2014 PJM Variable Resource Requirement Parameter Review

May 15, 2014

Re: VRR Curve Key Parameter Review, PJM Preliminary Recommendations

VRR Curve Shapes: Current Curve, Brattle Recommendation (Convex Tuned, 1.5x Cap) and PJM Preliminary Recommendation (Convex 1.5x, Right-Shifted 1%)

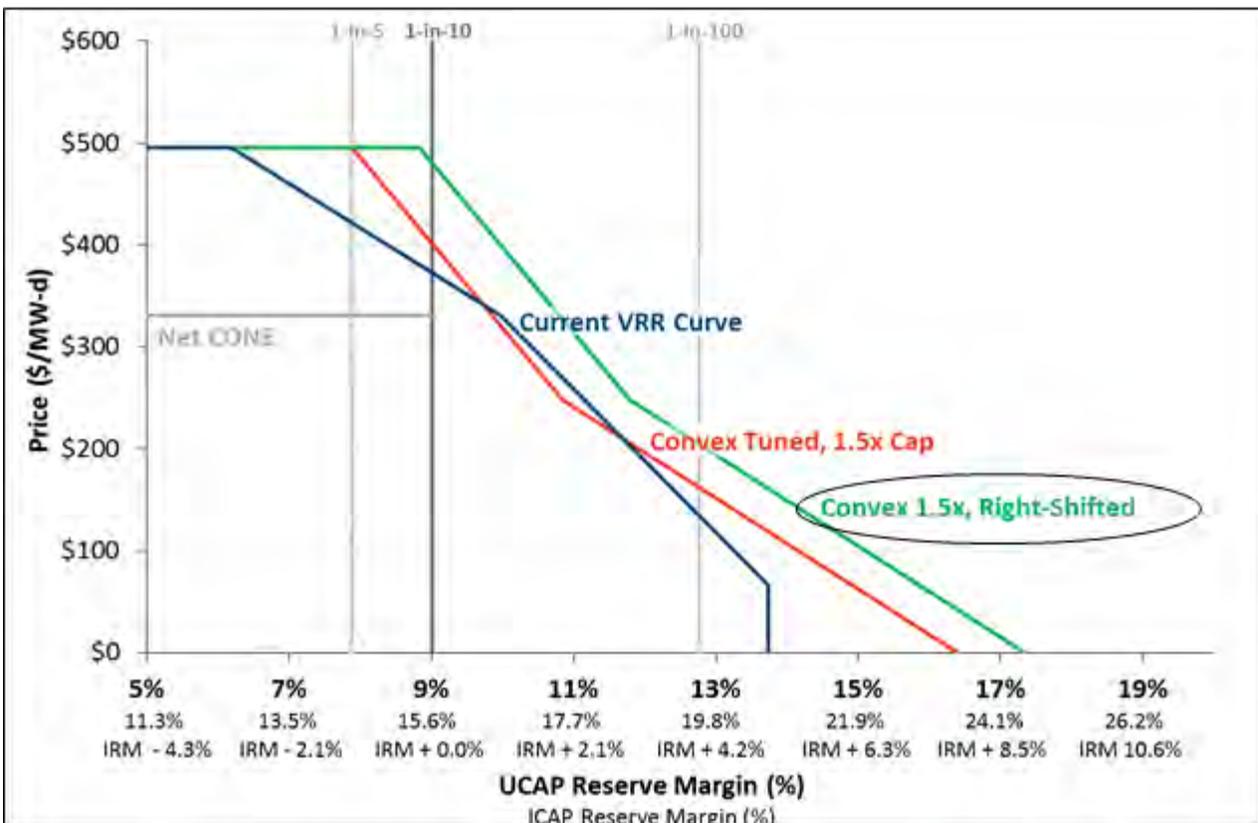
- System Curve
 - *Right shift the price cap (point “a”)*
 - Shifting point “a” to a quantity at 1-in-5 LOLE (approximately Installed Reserve Margin-1 percent) would significantly improve reliability outcomes by providing stronger price signals when capacity resource supplies are reduced or become more expensive and would not increase long-term average prices.

- *Stretch the VRR Curve into a convex shape*
 - This convex shaped curve is steeper at lower reserve margins and flatter at higher reserve margins. Under Brattle base modeling assumptions, the recommended convex curve will meet the 1-in-10 reliability standard on average.

- Local VRR Curve
 - *Adopt the system-level recommendations at LDA level, with additional recommendations to:*
 - *Increase the LDA price cap to 1.7x Net CONE*

- Brattle found that a higher cap substantially improves simulated outcomes in LDAs because stronger price signals when supplies become scarce.
 - *Impose a minimum curve width equal to 25 percent of Capacity Emergency Transfer Limit*

- ***Adopt the convex curve recommended by Brattle but right-shifted by 1 percent***

- This would mean new parameter values of:
 - Point a: Price cap maximum of (150 percent Net CONE, or 100 percent of Gross CONE) at UCAP level of (IRM - 0.2 percent)

- Point b: Price of 75 percent Net CONE at UCAP level of (IRM + 2.9 percent)
 - Point c: Zero price at UCAP level of (IRM + 8.8 percent)
 - Through probabilistic simulation modeling, Brattle found that the current shape does not meet the 1-in-10 objective on average and shows procurement below the reliability requirement 35 percent of the time. The Brattle-recommended convex curve meets the 1-in-10 objective but still shows procurement below the reliability requirement 29 percent of the time.

- PJM's recommended convex curve shows procurement below the reliability requirement only 16 percent of the time. It meets the 1-in-10 objective and it allows RPM to better handle year-to-year volatility in system conditions. While this curve does not meet the reliability target 100 percent of the time in simulations, PJM believes this curve strikes an appropriate balance between reliability objectives and minimizing overall cost to consumers.

- **Use the same curve for LDAs as is used for the System**
 - PJM recommends using the same curves for LDAs as are used for the system.
